Network Camera Firmware

Version: V5.5.114

Release Note (**External**)

Hikvision IP Camera Firmware V5.5.114 build200417 Features

Device Auto Maintenance

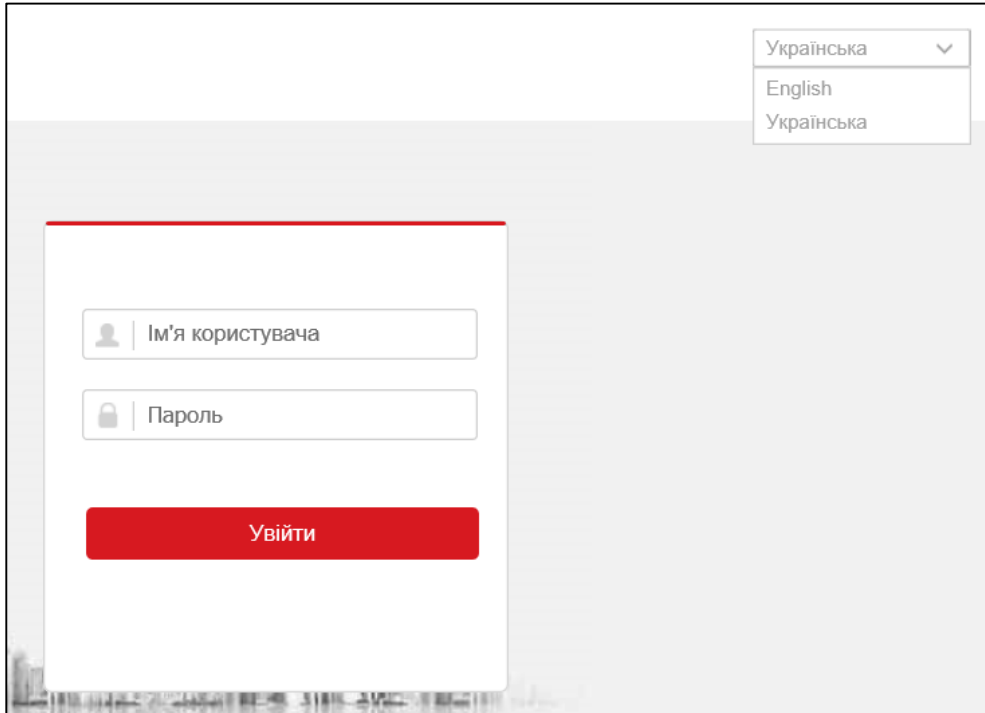
- Newly support Device Auto Maintenance, on System—Maintenance page, and supports automatic restart at a specific time point, with a weekly cycle, only available for Admin account;

Domain Name Settings

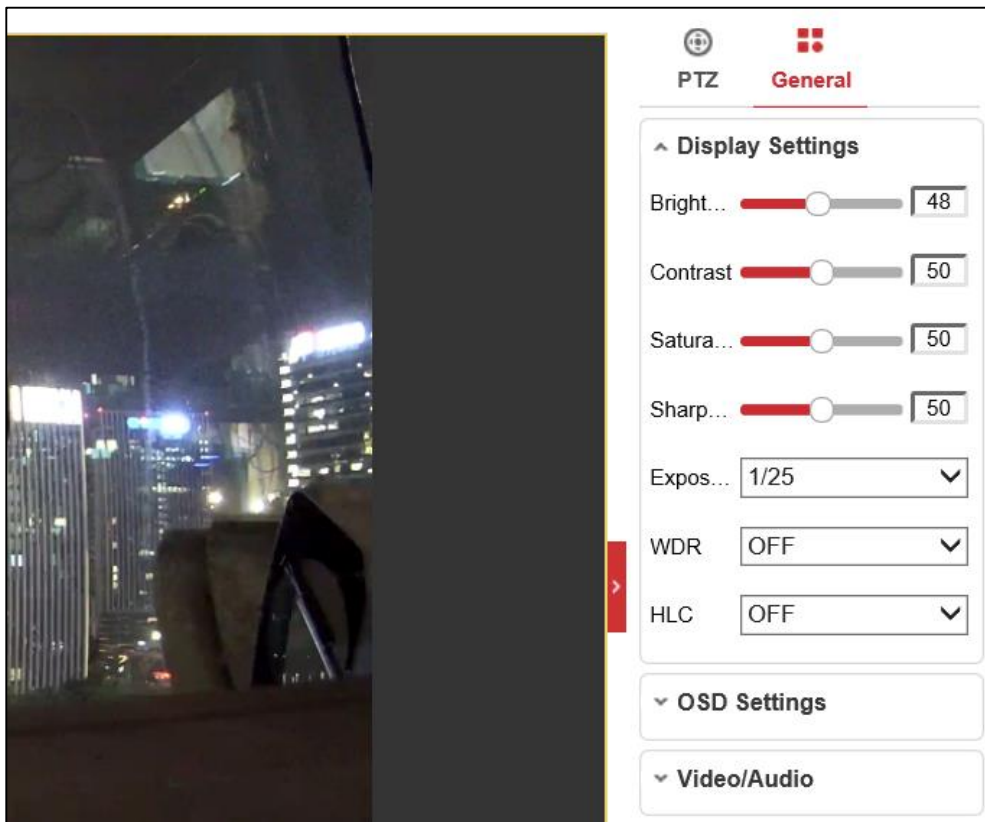
- Newly support Domain Name Settings, on Network--TCP / IP page, which requires the device to enable DHCP;
